PERMIT

SEWAGE DISPOSAL SYSTEM

SUBDIVISION Sharp Farms LOT 222 ROAD 3718 Appleby Court

PROPERTY OWNER David & Sharon Putman

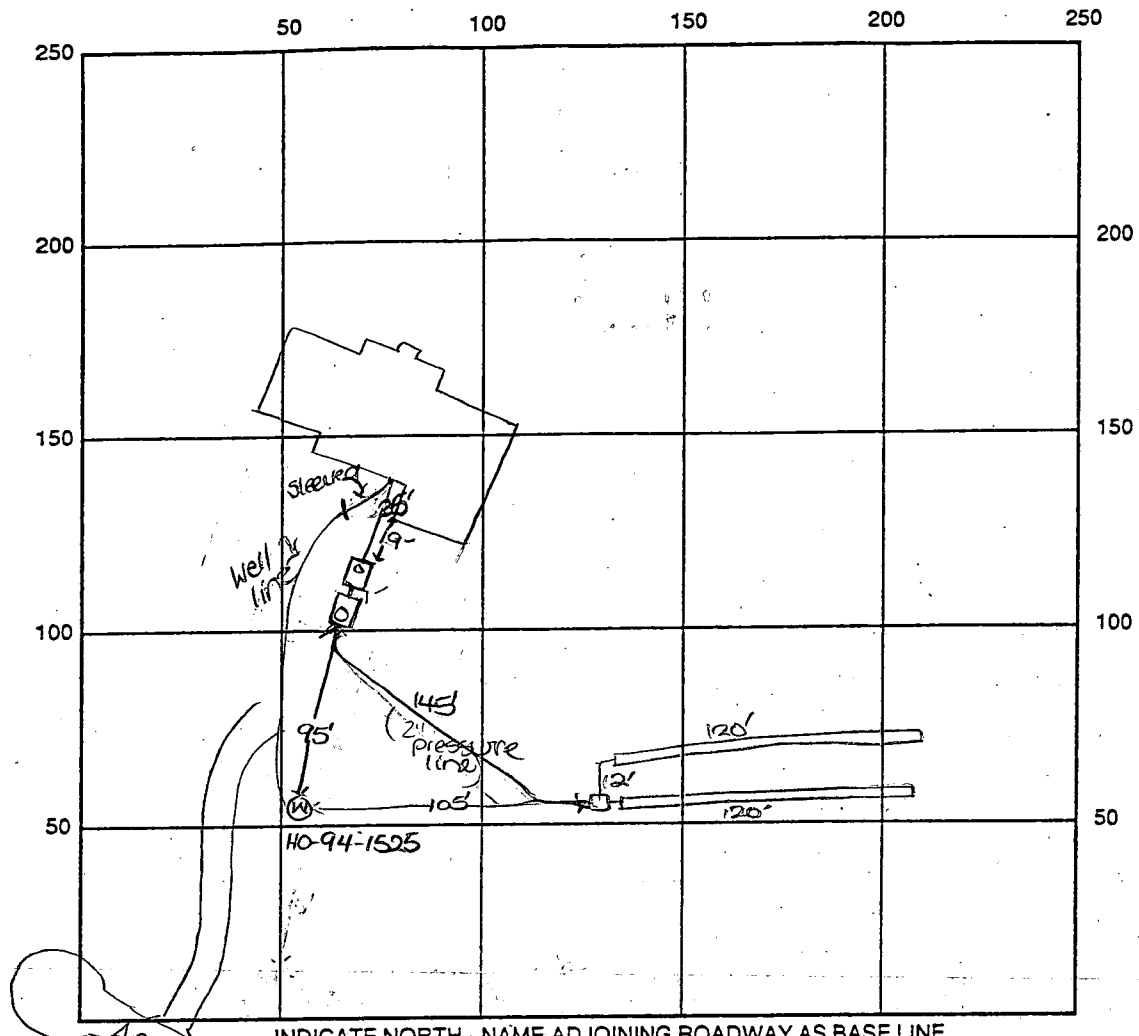
REMARKS: 8/17/98 A.M. OK to cover 1st trench and continue.
(Proposed top-seamed pump chamber location is 95'
from ex. water well - owner accepts this deviation
from standard). DKS

8/17/98 P.M. OK to cover all septic work - Needs pump perf. test. DKS

*12/10/99 No pump performance test @ this time - file indexed
 system not approved*

MODIFIED SEPTIC EASEMENT

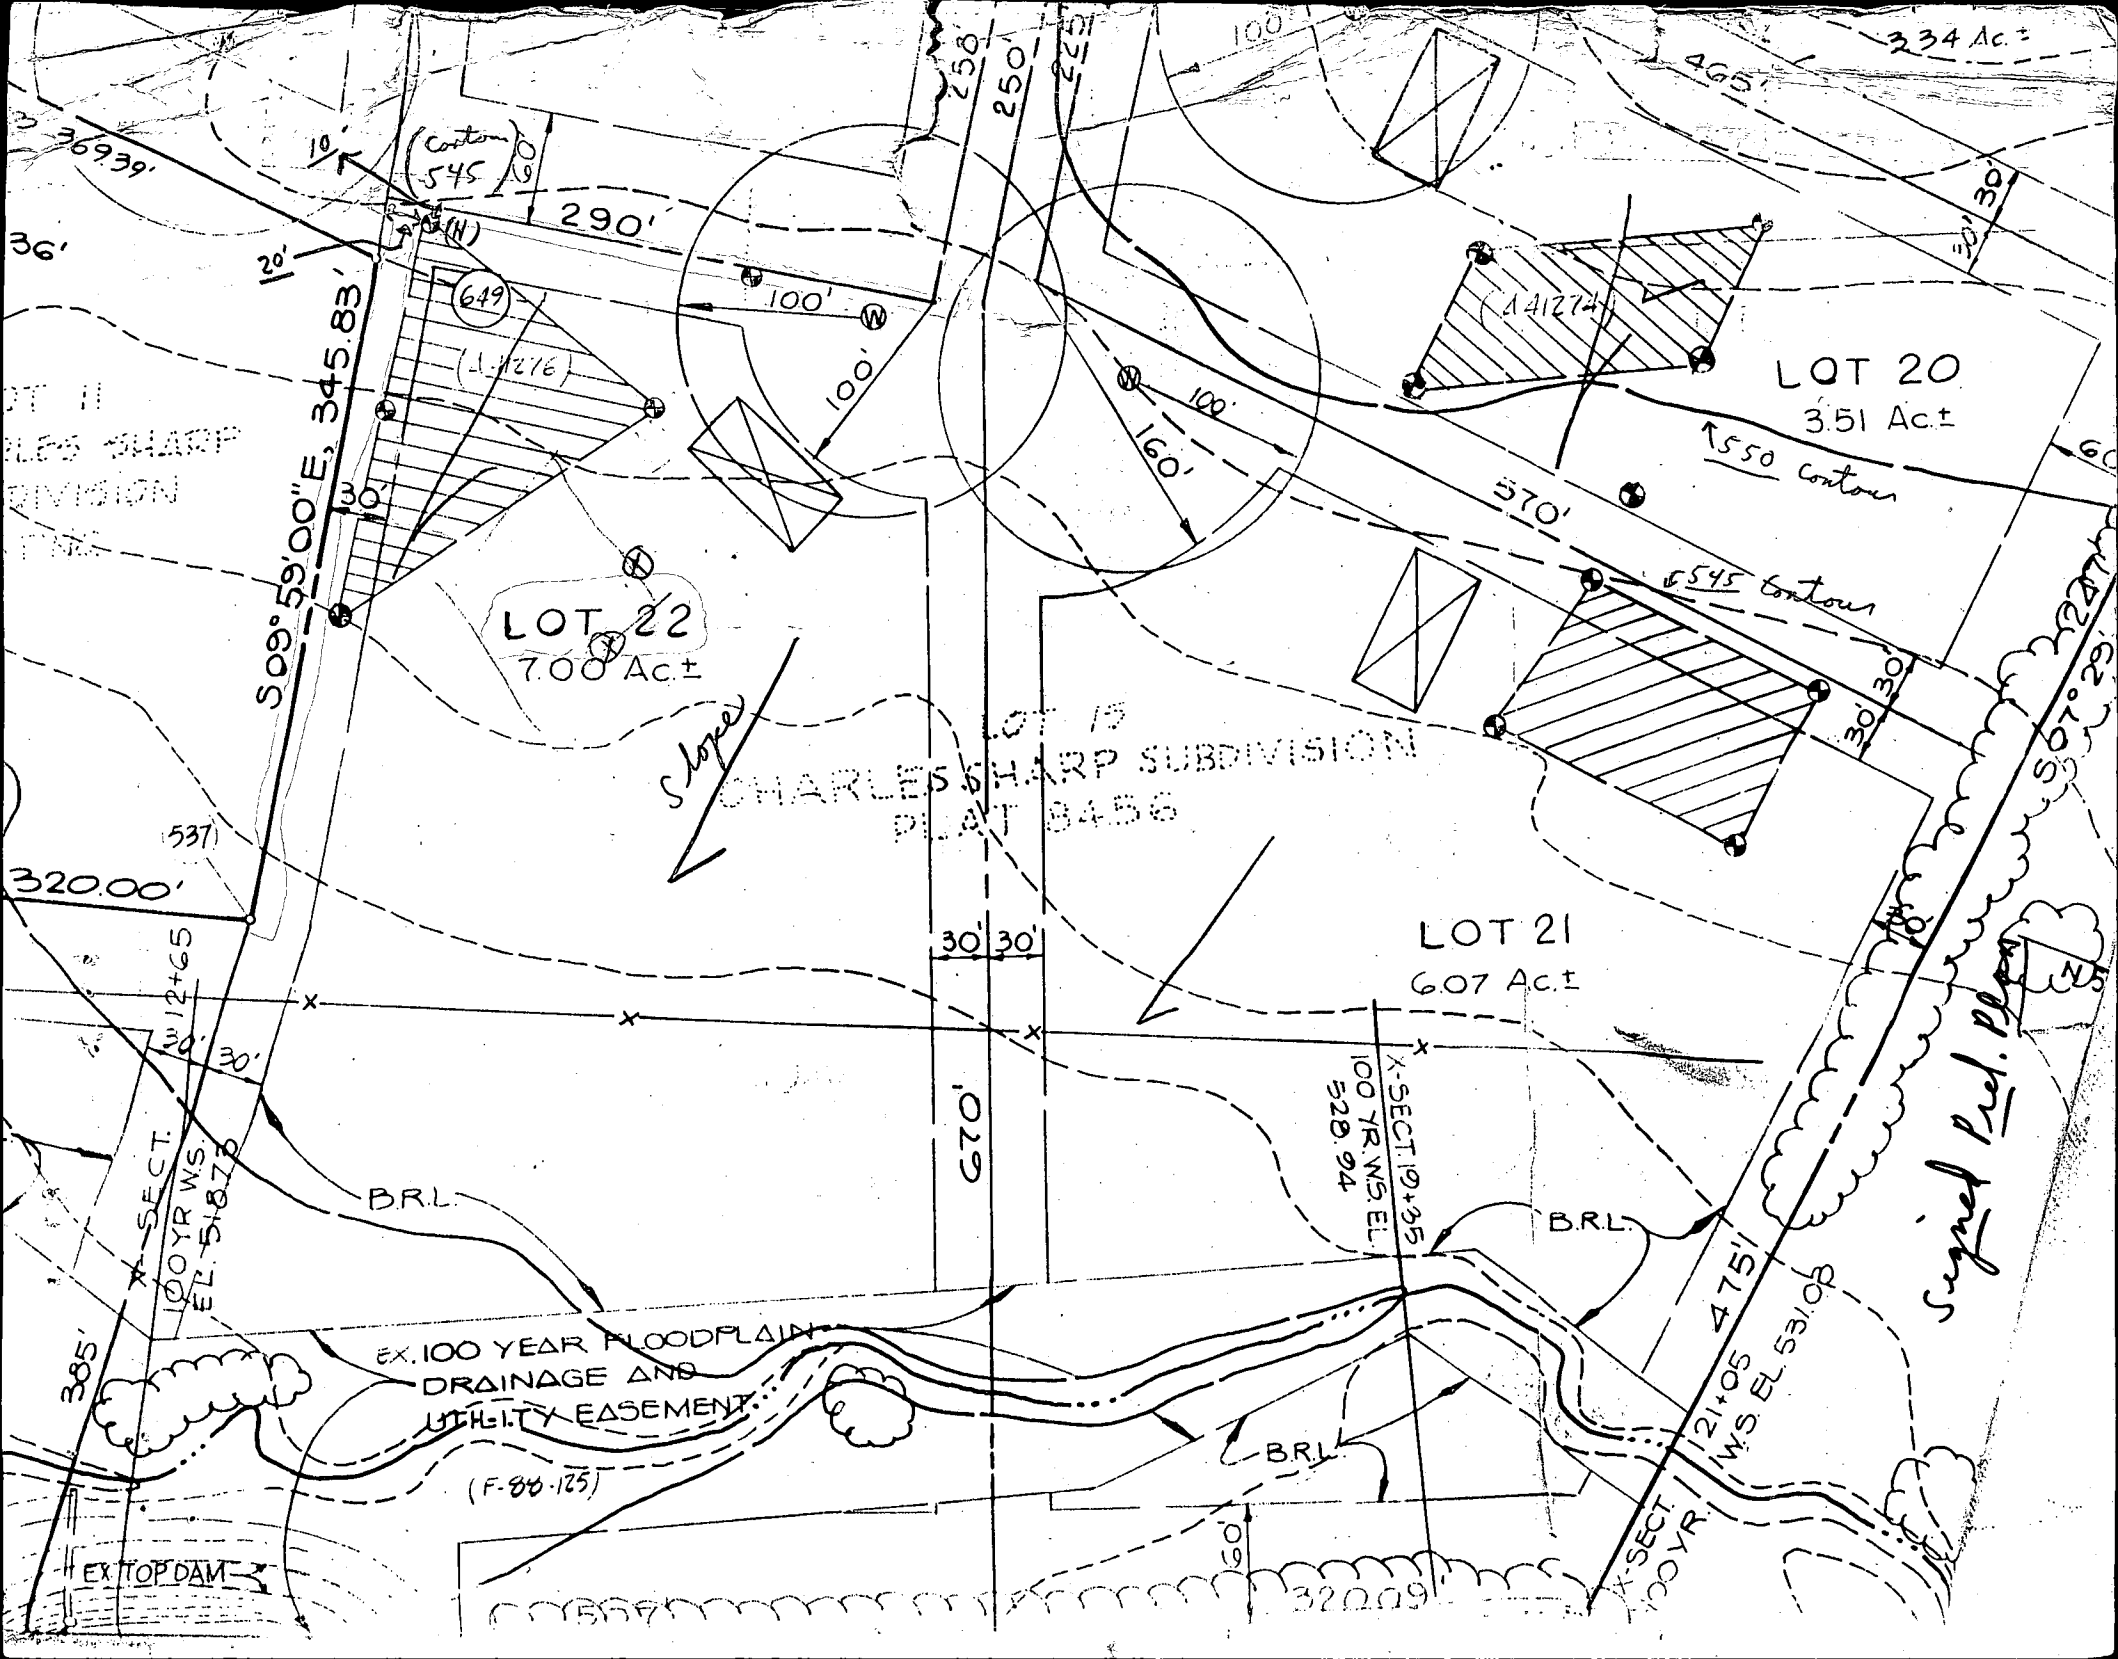
Due to potential water table concerns with the lower third of the approved septic area on your property, modification to the existing septic area is necessary. Please find enclosed a copy of the approved final plat for the property indicating the modification to the septic area. I trust that this modification shall not adversely effect potential house site.
